Messenger III, Part No. 242-0143-xxx  
Messenger III, Part No. 242-0150-xxx  
Messenger 100, Part No. 242-0152-xxx  
Messenger 100, Part No. 242-0156-xxx  
Messenger 102, Part No. 242-0102-xxx  
Messenger 110, Part No. 242-0110-xxx  
Messenger 123, Part No. 242-0123-xxx  
Messenger 124, Part No. 242-0124-xxx  
Messenger 124M, Part No. 242-0134-xxx  
Messenger 300, Part No. 242-0149-xxx  
Messenger 303, Part No. 242-0151-001/-007  
Messenger 320, Part No. 242-0320-xxx  
Messenger 323, Part No. 242-0153-xxx  
Messenger 323M, Part No. 242-0158-xxx  
Messenger 333, Part No. 242-0151-401/-407

Transistor Substitution

Figure 1

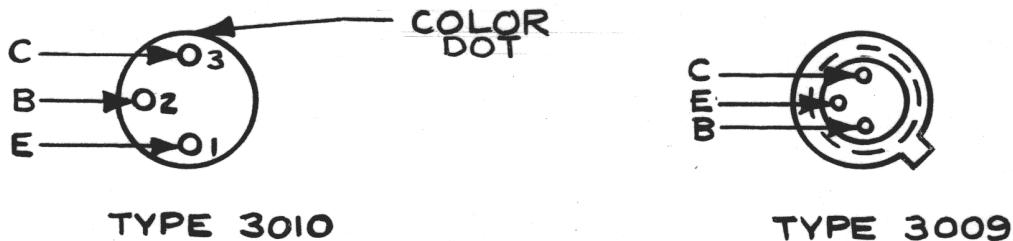
The 576-0003-009 (type 3009) transistors can be substituted for the 576-0003-010 (type 3010), IF and AGC transistors. Refer to Figure 1 for the different lead configuration.

Make this transistor substitution when the 3010 type is unavailable.
